**Service Bulletin**

**No. :** MZ09-005

**Model:** SA8003

**Subject:** Remote Control Performance Improvement

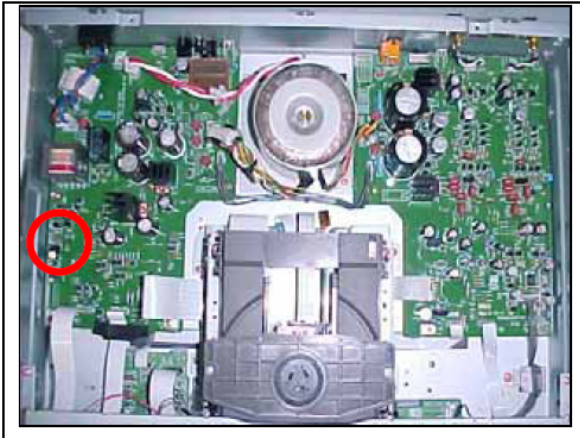
**Symptom:** When the unit receives remote control codes (from another model) during standby and the AC power supply voltage is reduced for 6% or more, the LED gets dim and the relay may turn on and off one time.

**Cause:** When the microprocessor receives remote control codes during standby, it shifts from Low Speed mode to High Speed mode and starts analyzing remote control codes. The analysis takes approximately one second only, but while this is happening, the voltage of the standby power supply is gradually reduced until the voltage of the microprocessor power supply falls below that of the reset power supply, and thereby the reset is activated. This phenomenon occurs when the voltage is reduced for 6% or more.

**Solution:** The input of the microprocessor regulator has a built-in circuit that lowers the voltage during standby. The fixed voltage number of this circuit should be changed to be capable of guaranteeing normal function at the 15% reduced voltage.

The 1.5K Ohm resistor of POS NO. RH10 (PP16 POWER PWB) is to be replaced with 820 Ohm.
